**BILLYARD AVE DEVELOPMENTS PTY LTD ATF BILLYARD AVENUE DEVELOPMENT TRUST V  
CITY OF SYDNEY COUNCIL**

**21C Billyard Avenue, ELIZABETH BAY**

**SUPPLEMENTARY JOINT EXPERT REPORT ADDRESSING HEIGHT OF BUILDINGS  
CALCULATION**

Supplementary Joint Expert Report  
Appendix B: Height Plane Amendment

# Bettar Height Plane - Comparison

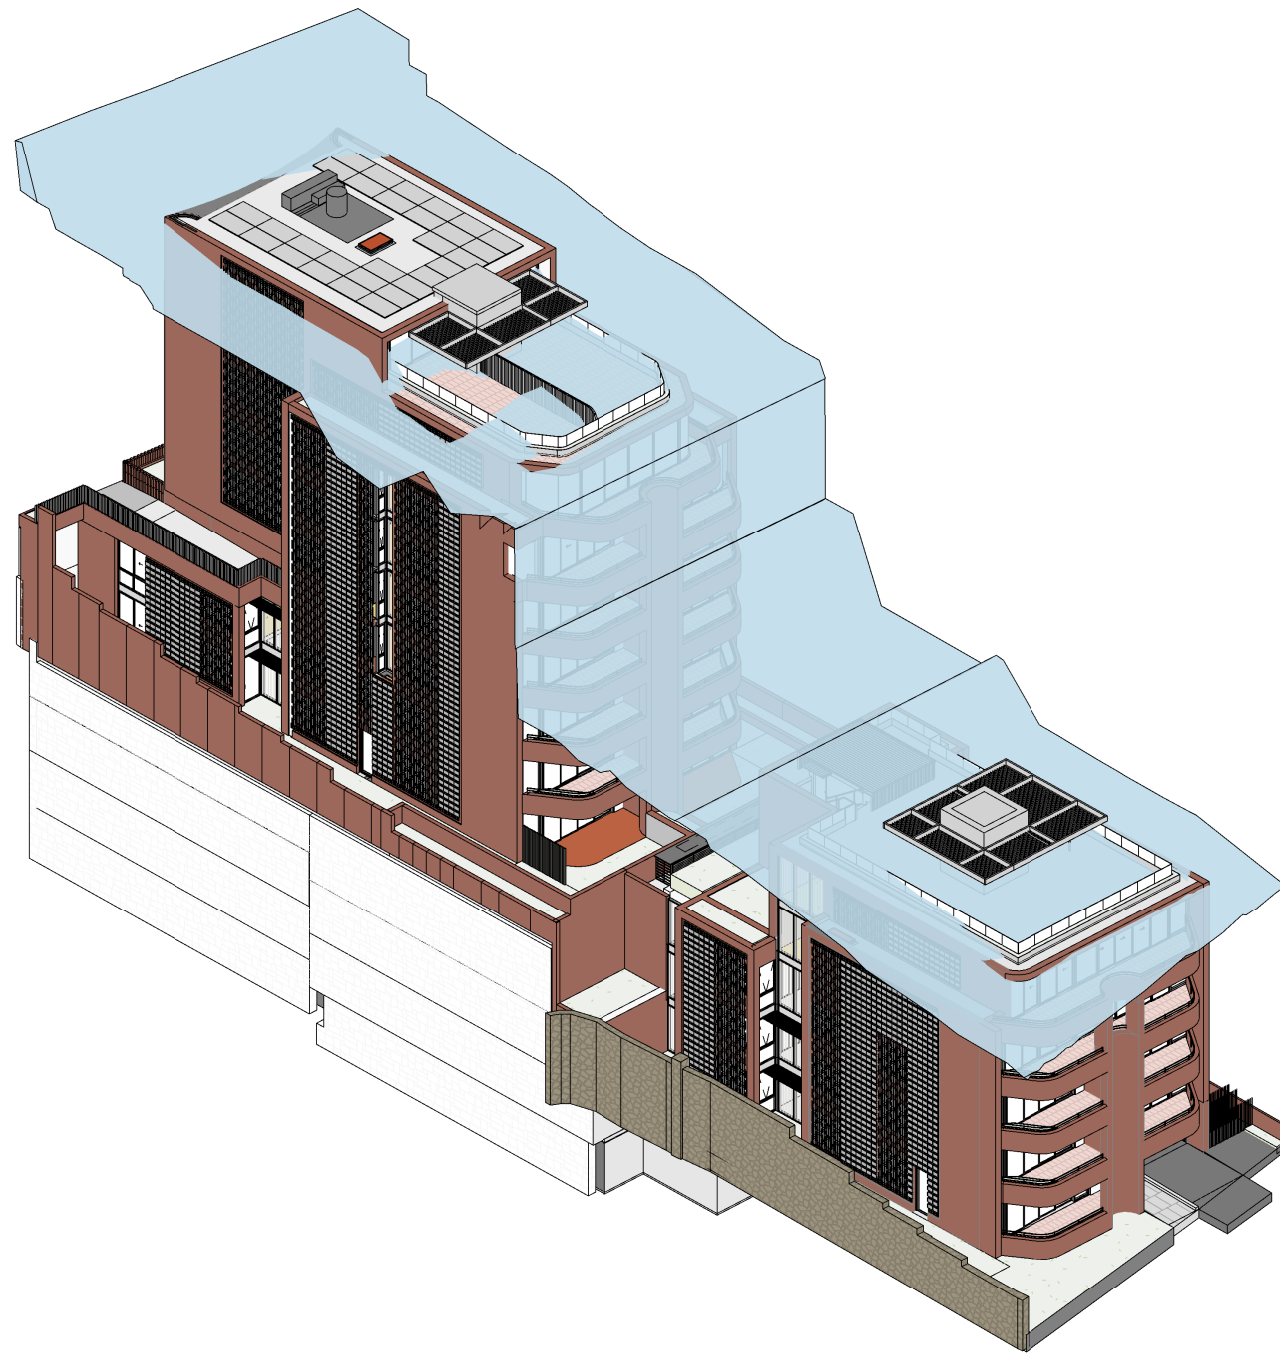
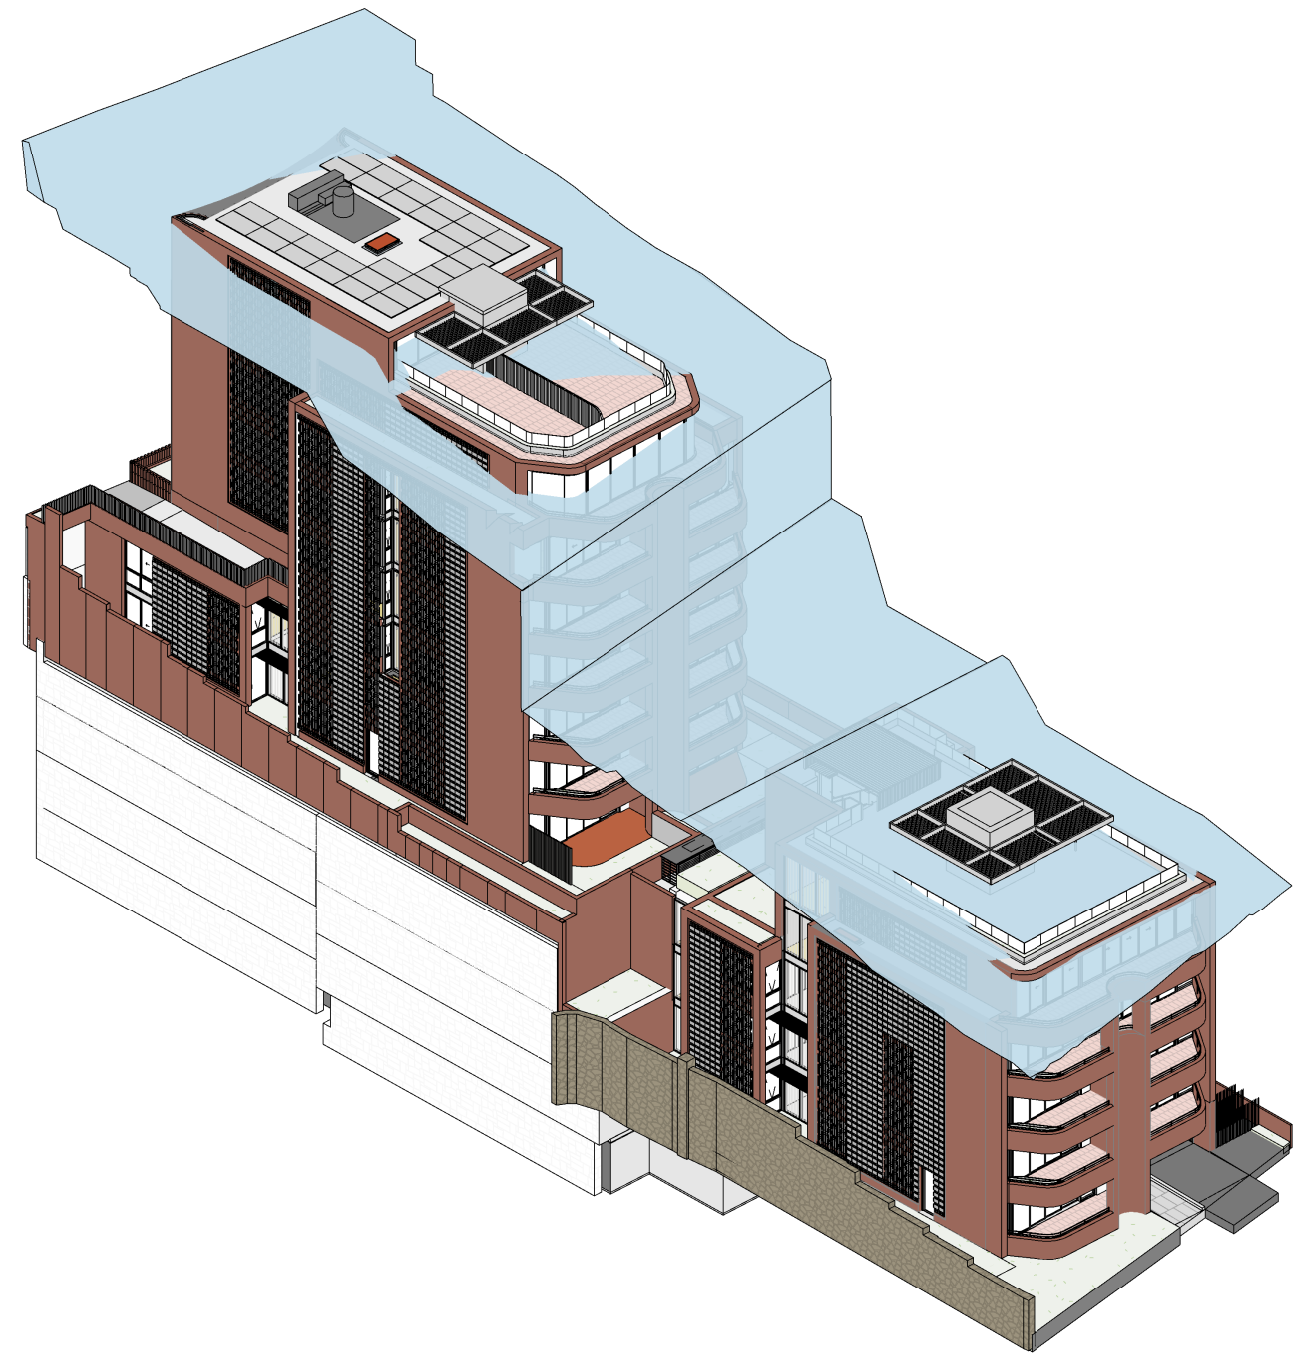
Current: DA Issue 09

Amended

## Bettar Height Plane - Additional Exceedance

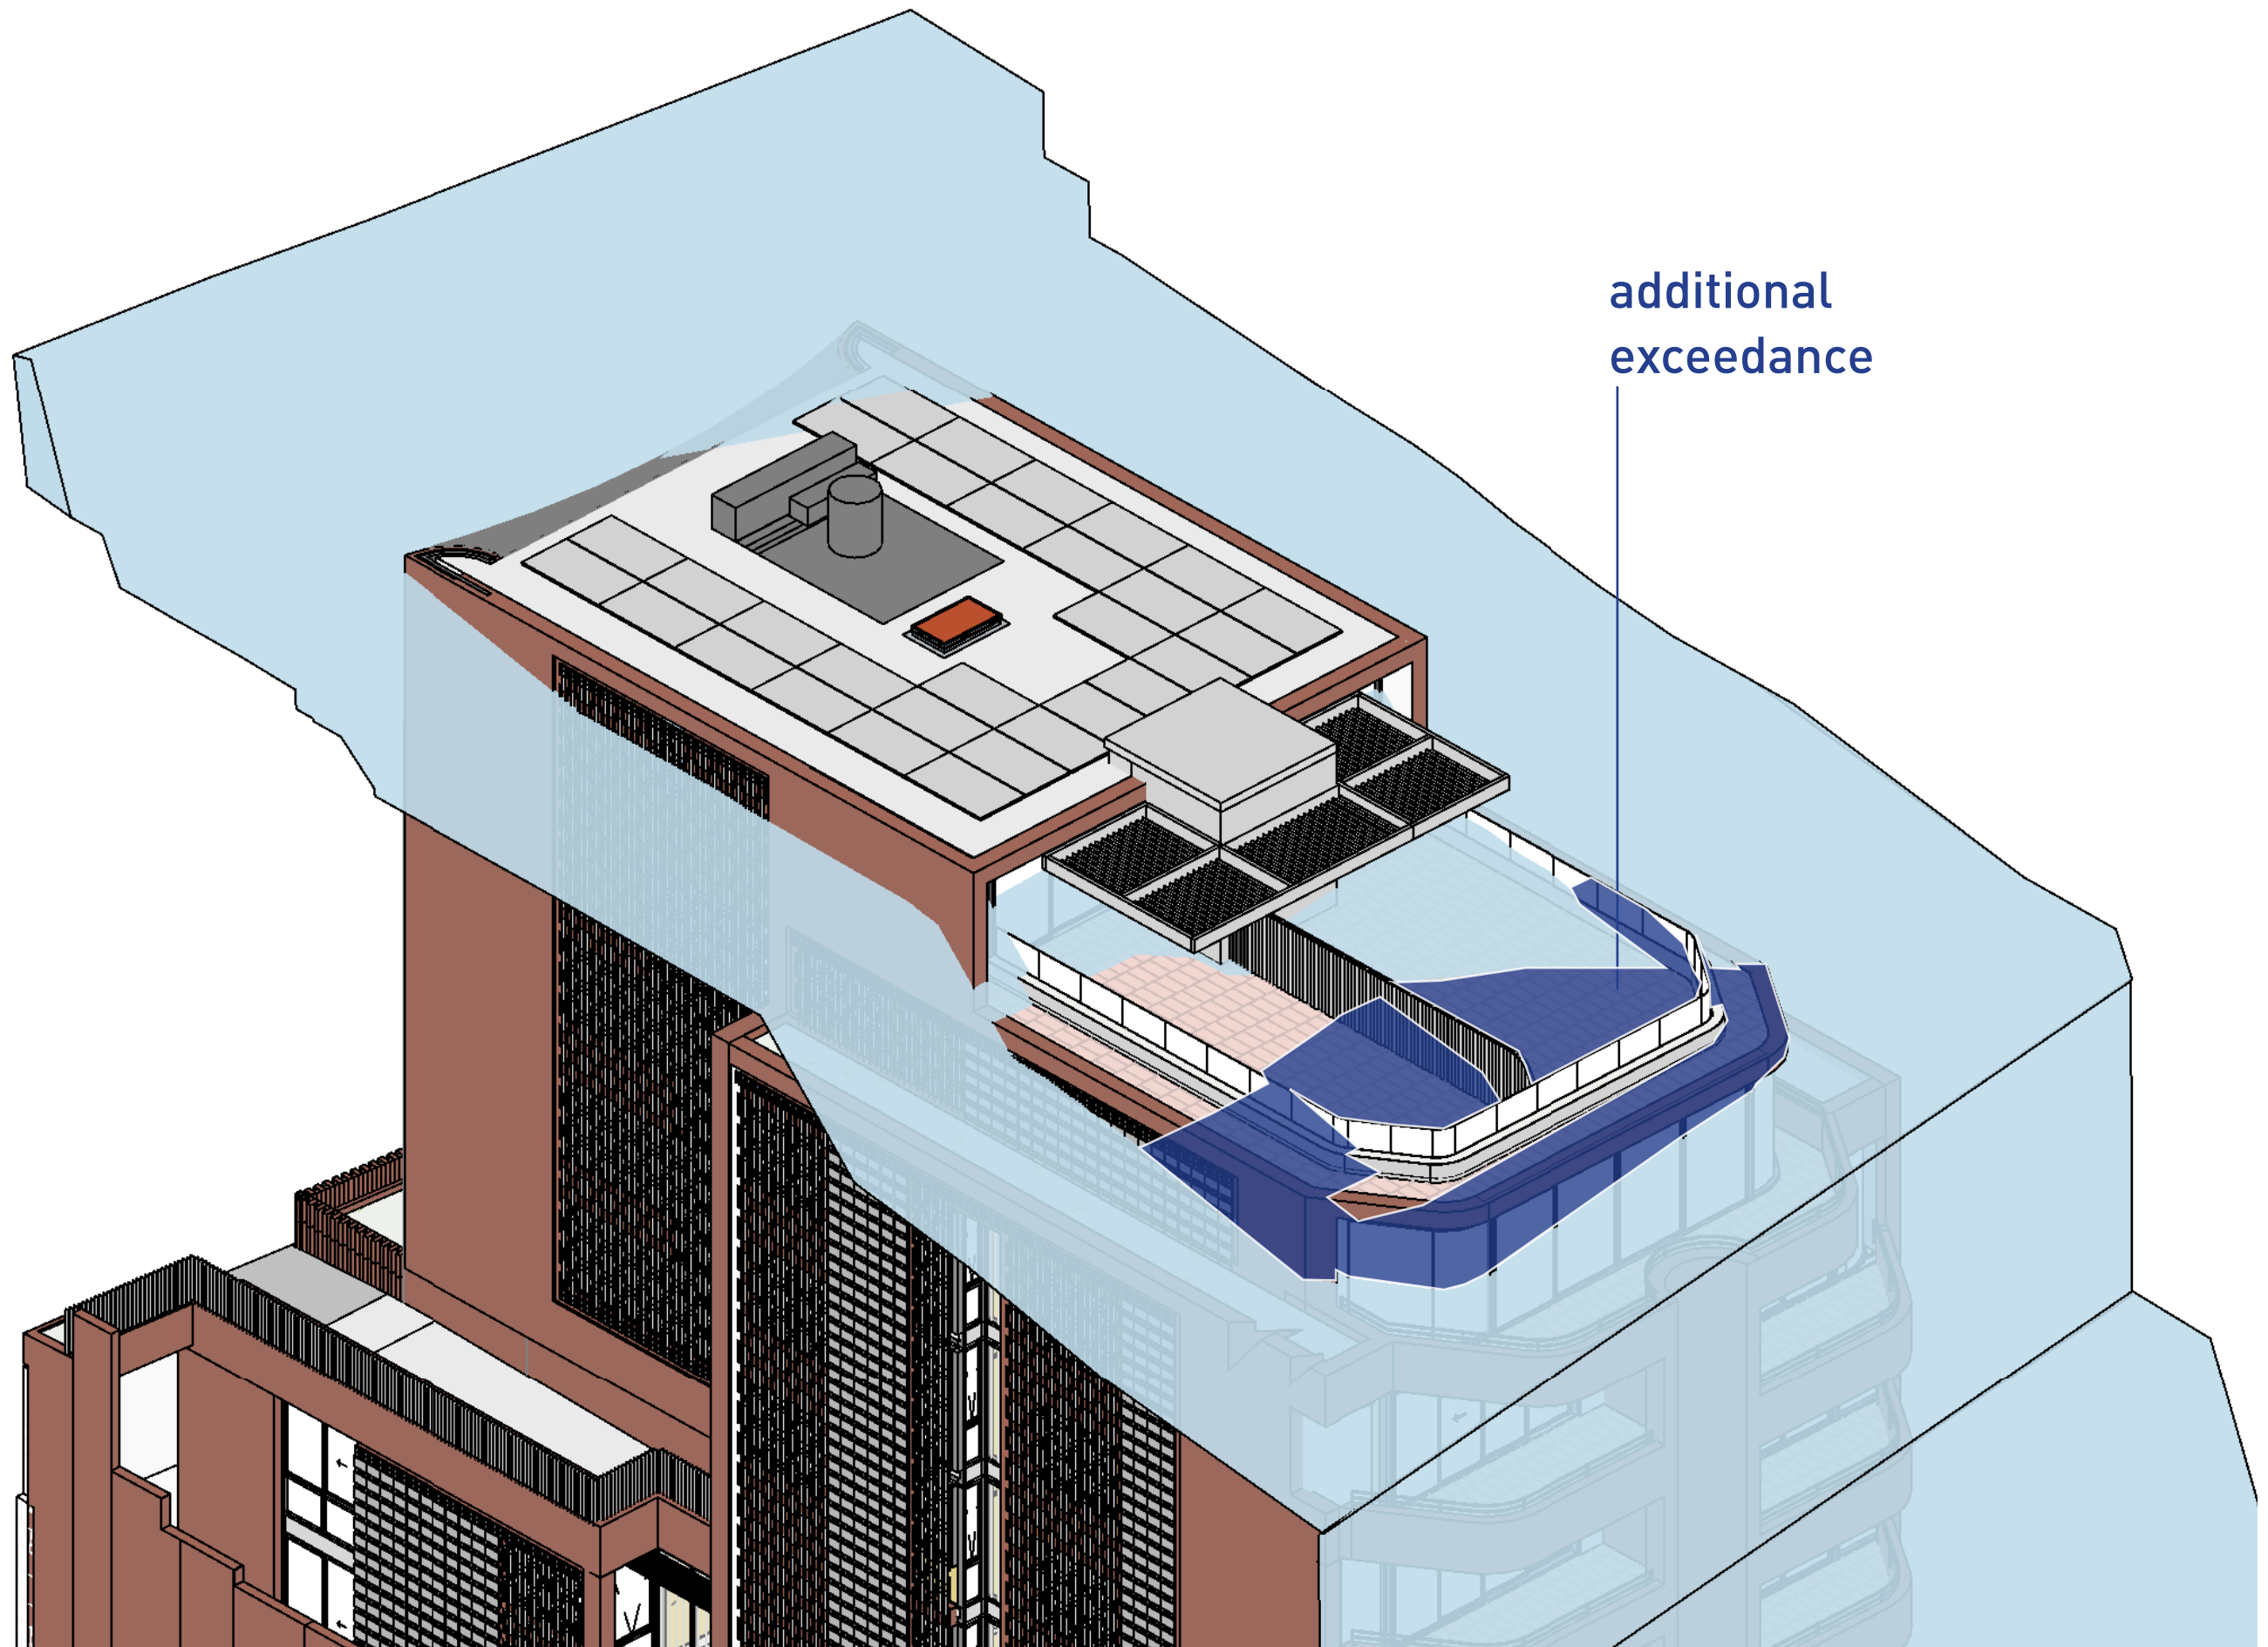
Whilst the building envelope and form has not changed in this amendment, the proportion of the building that exceeds the newly established LEP height limit has increased in the north-eastern corner of the Onslow Avenue building.
